WATER MAIN STATION
 HOR. SCALE 1" = 20'-0"
 VER. SCALE 1" = 4'-0"

WATER AND SEWER PLANS		PROJECT NAME: RUTLAND CITY
		PROJECT NUMBER: BRF 3000(18)
	FILE NAME: \$FILEABBREV\$	PLOT DATE: 3/5/2014
	PROJECT LEADER: C. BEAN	DRAWN BY: W. GORDON
	DESIGNED BY: D. LEWIS	CHECKED BY: S. REICHERT
	WATER PROFILE	SHEET 7 OF 7

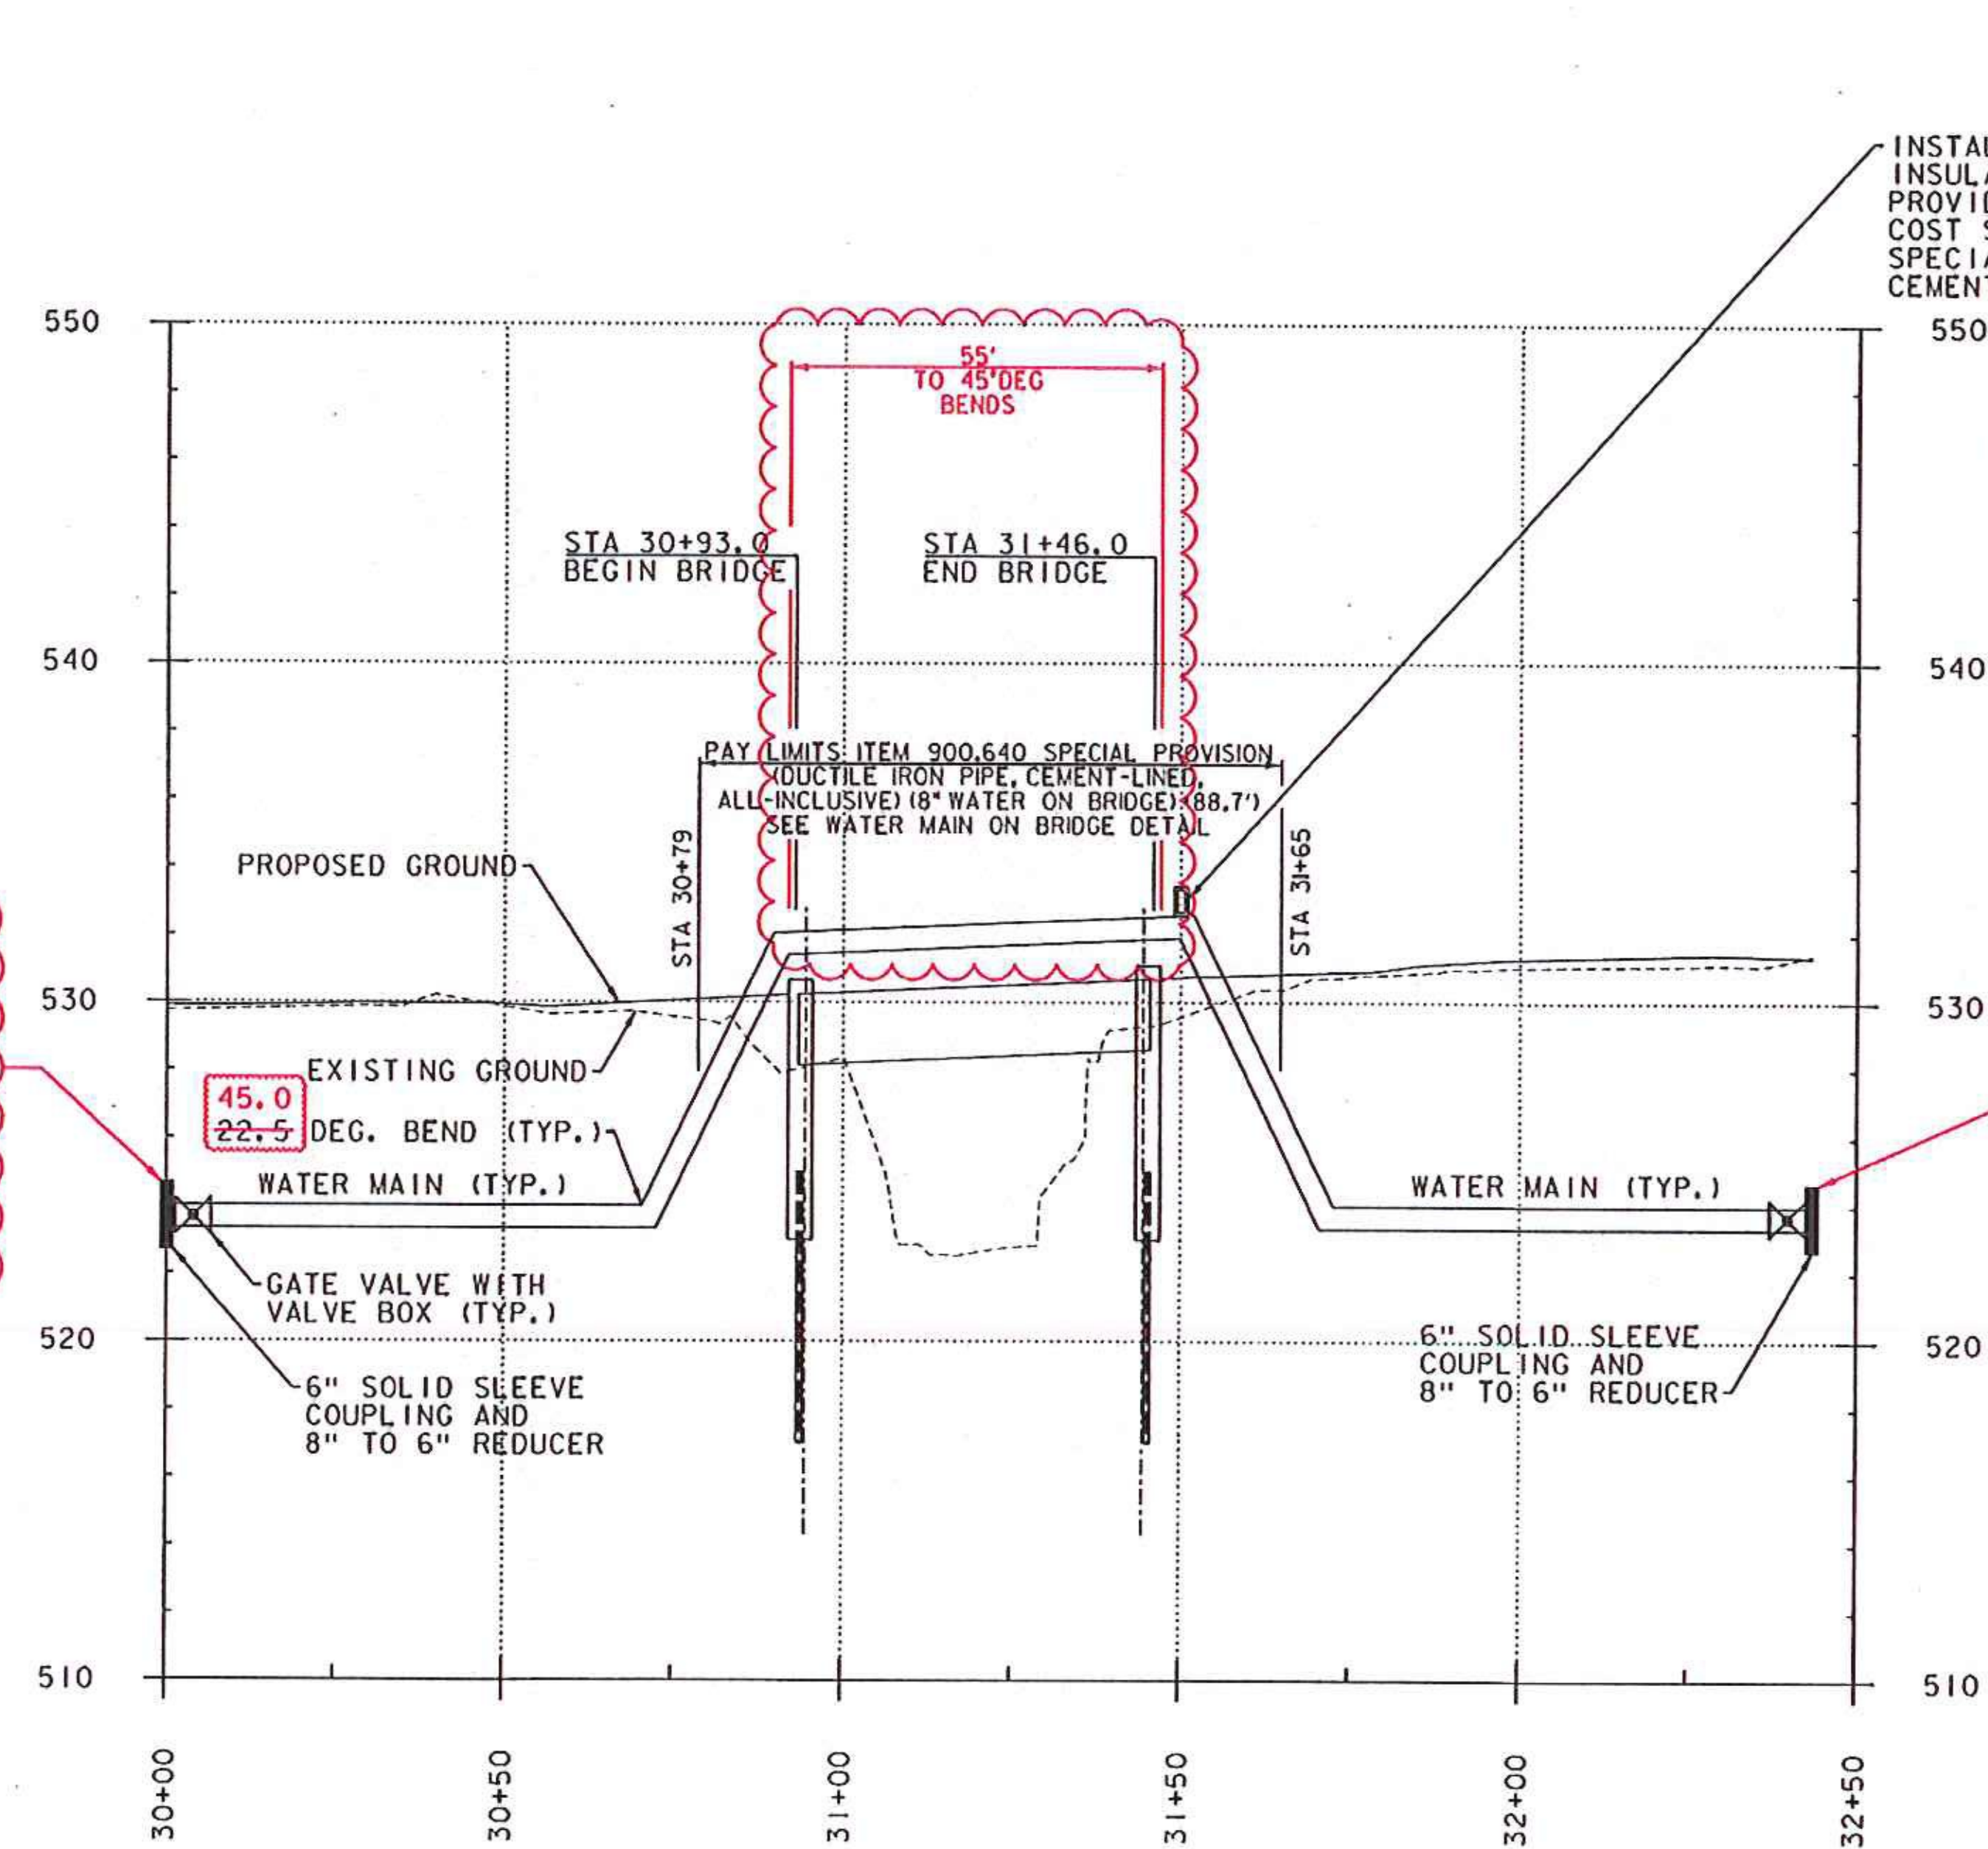
INSTALL AIR RELIEF VALVE WITH WEATHERPROOF, INSULATED AND LOCKABLE ENCLOSURE. PROVIDE FABRICATION DRAWING FOR REVIEW. COST SHALL BE INCIDENTAL TO ITEM 900.640 SPECIAL PROVISION (DUCTILE IRON PIPE, CEMENT-LINED, ALL-INCLUSIVE) (8" WATER ON BRIDGE)

NOT REQUIRED BY CITY

- 3 RECORD CHANGES CLOUD
- PLAN REVISIONS
- 2 3/5/14: REVISED WATER MAIN PROFILE ON BRIDGE TO ACCOMMODATE HANGER INSTALLATION REQUIREMENTS. REVISED AIR RELIEF VALVE AND GATE VALVE LOCATIONS.
- 1 1/16/14: ADDED NOTE TO DEFINE INSULATION EXTENT AND CORRECTED SCALE (PER DEC).
